## REQUEST FOR INFORMATION

### Request #7

**Project: Replacement of Air Conditioning  
Units at Malaga Elementary School  
John Sutter Middle School  
Fowler High School for  
Fowler Unified School District**

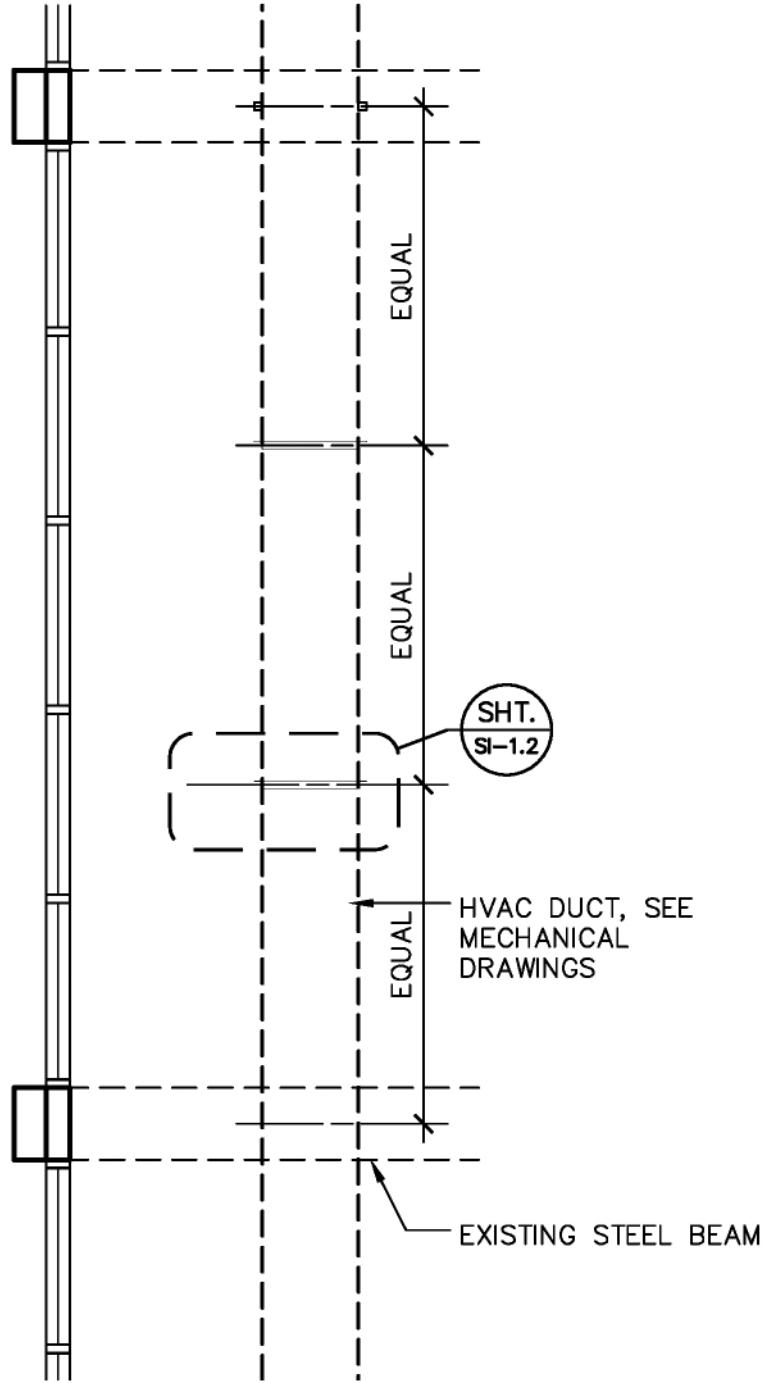
**Description:** Fowler High School Gym, The point of connection for the new gas lines does not exist in the appropriate area, view attached. As we investigated, we found two possible points of connections at existing heaters.

**Recommendation:** Tie into the gas lines at the existing heaters. See attached plans.
